Addendum

Additions and Alterations to
Elm Street Elementary School
Phase 2

RE-BID Addendum No.2
to
Drawings and Project Manual

November 4, 2026

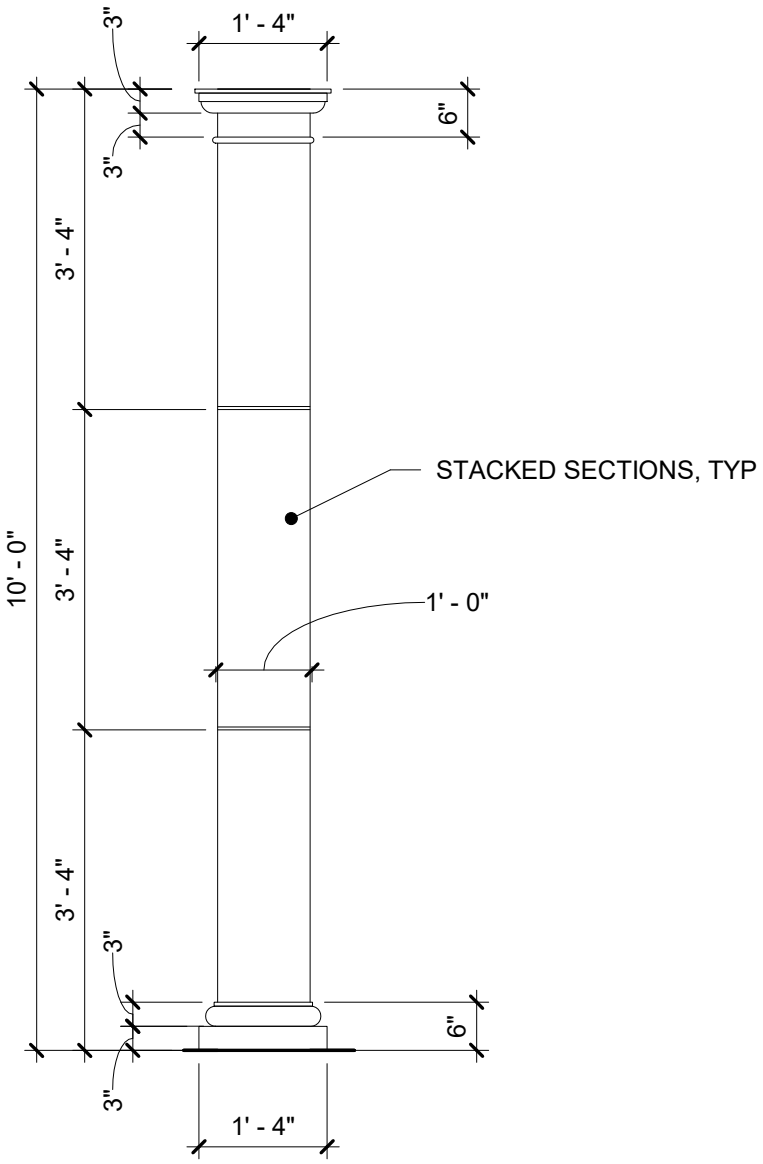
1) Elevation 1/BA200 (Plan view on 1/BA130 & 13/BA900) shows two entry columns labeled as Item 12: 12" dia cast stone columns with tuscan capital and base. In order to price the mold for these columns, I need some idea of how ornate they are at the capitals and bases and need to know if the columns are tapered or straight. Please provide an enlarged dimensioned detail showing the design desired for the cast stone columns.

2) The column is shown as solid at 19/BA500. Fancy cast stone columns are typically cast as hollow halves around a center steel column which allows them to be cast horizontally. Casting a one-piece structural column means that the columns would need to be cast vertically standing up which is very difficult (my shop wouldn't be able to lift the concrete hopper high enough to fill the mold). Please confirm that the columns are indeed to be one-piece structural units as seems to be indicated at 19/BA500. If they are to be wrapped around a steel column, please provide a revised detail.

There is not steel in this location and columns are not structural, steel structure cantilevers, refer to structural drawings. A larger scale detail will be provided by addendum.
